Public Service of New Hampshire

SEABROOK STATION
Engineering Office:
1671 Worcester Road
Framingham, Massachusetts 01701
(617) - 872 - 8100

Subject: Open Item Response (SER Section 9.3.4.2; Chemical Engineering
Branch)

In response to the Open Item included in the Safety Evaluation Report
(Section 9.3.4.2) regarding NUREG-0737, Item II.B.3 (Post-Accident Sampling
Capability) we have enclosed a report which addresses the status of our
compliance with each of the Item II.B.3 criteria. We have included
commitments to complete the development of sampling and analysis procedures,
shielding studies, and sampling system time and motion studies not later than
six months prior to fuel load.

FIGURE 9.3-5c

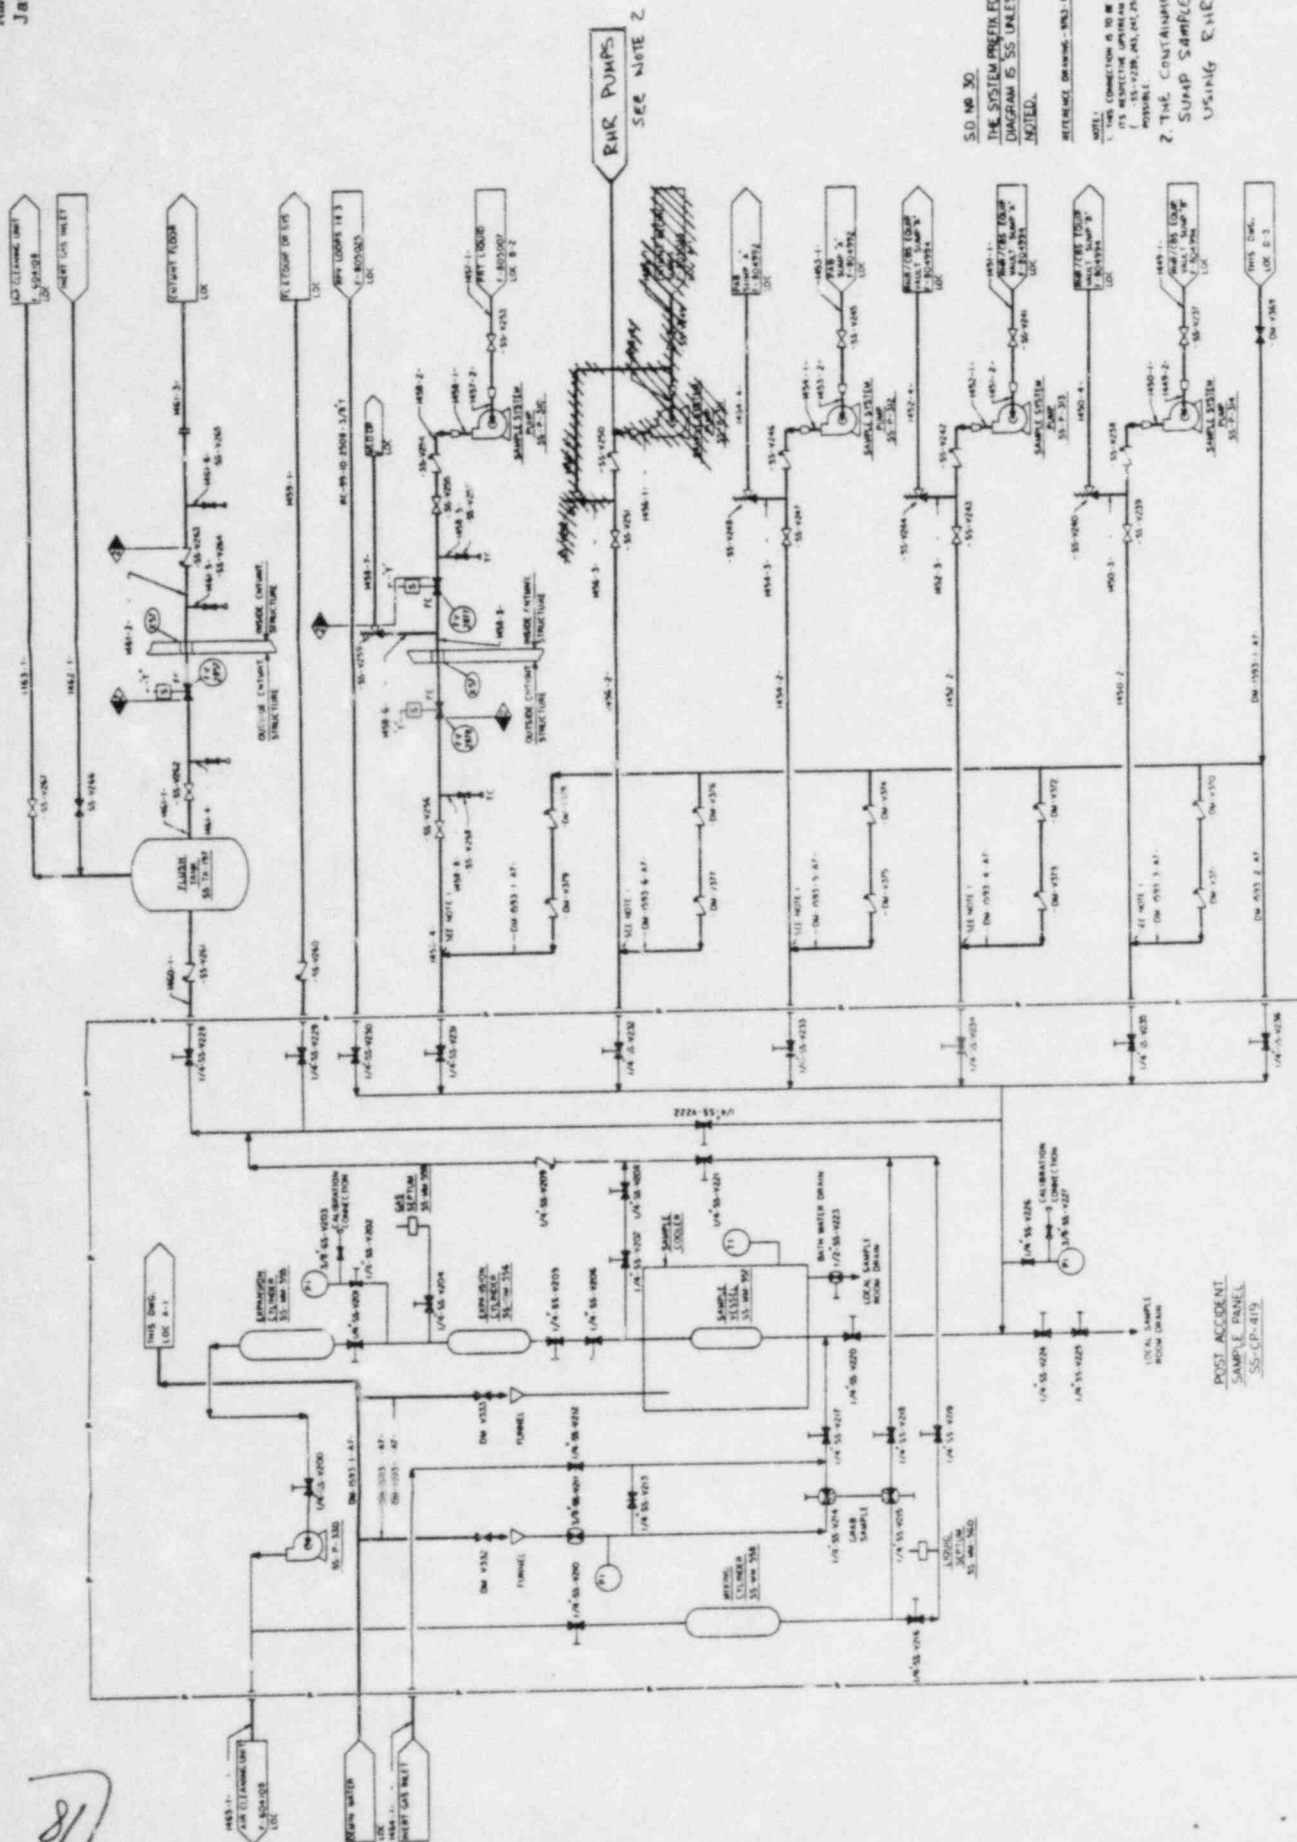
- 2 (b) Show a capability to obtain a grab sample, transport and analyze for hydrogen.
- 2 (c) Discuss the capabilities to sample and analyze for the accident sample species listed here and in Regulatory Guide 1.97 Rev. 2.

Reactor coolant and containment atmosphere sampling during postaccident conditions shall not require an isolated auxiliary system [e.g., the letdown system, reactor water cleanup system (RWCUS)] to be placed in operation in order to use the sampling system.

In the case of the RCS sampling system, samples can be supplied to the panel directly from reactor coolant loops 1 and 3 (hot legs), the discharge of either RHR pump (containment recirculation sump sample), the discharge of the pressurizer relief tank sample pump, the discharge of the IAB sump "A" sample pump, and the discharge from either RHR/CB3 equipment vault "A" or "B" sump sample pump. See revised FSAR Figure 9.3-5c, attached, and FSAR Figure 9.3-5a.

The Post-Accident Sampling System (see revised FSAR Figure 9.3-5c, attached and FSAR Figure 9.3-5a) is capable of obtaining samples from reactor coolant loops 1 and 3 under accident conditions where the Reactor Coolant System remains pressurized. Under these conditions, natural circulation could be established to remove decay heat and provide mixing of the RCS water.

The sampling system is purged using demineralized water which is flushed through the system. In the event of a loss of off-site power, the sample system is purged by establishing flow through the sample line, panel and returning the flow to the containment. See revised FSAR Figure 9.3-5c, attached.
